PROJECT  
RESERVE AT THE  
BALLPARK, PHASE II,  
AKA REVEL AT THE  
BALLPARK  
2885 CRESCENT PKWY  
SMYRNA, GA 30080

DATE 05/22/2017  
JOB NUMBER 1493101  
DRAWN BY EKS/NB  
CHECKED BY CW  
SHEET TITLE BUILDING 4000 - PROJECT LEVEL 4  
SHEET NUMBER  
COMMENTS BUILDING PERMIT RE-SUBMISSION  
30X42 © 2017 The Preston Partnership, LLC

A1-41

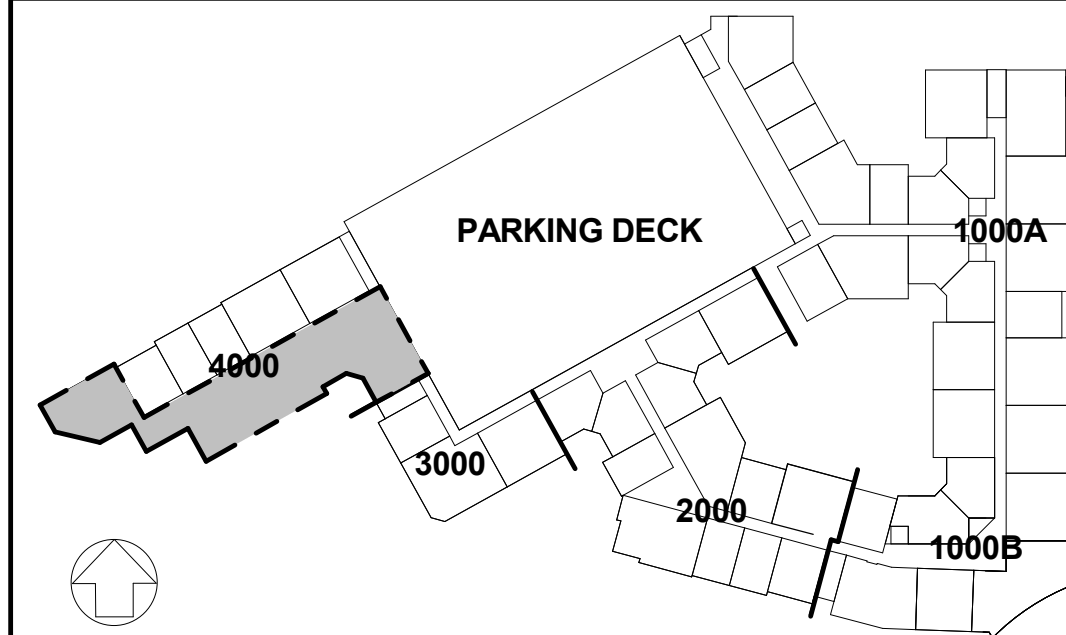
REVISION SUMMARY #1  
A. CHANGED STAIR 4 TO STAIR E  
B. CHANGED STAIR 3 TO STAIR D

REVISION SUMMARY #2  
A. CHANGED DOOR B03 TO DOOR B15  
B. CHANGED BEARING WALL 1B6 TO NON-BEARING WALL X86

REVISION SUMMARY #5  
A. MOVED FIREWALL, MOVED LOCATION OF DOUBLE DOOR, AND ADDED STANDPIPE  
B. RELOCATED EXTERIOR DOOR & ADDITIONAL NOTE
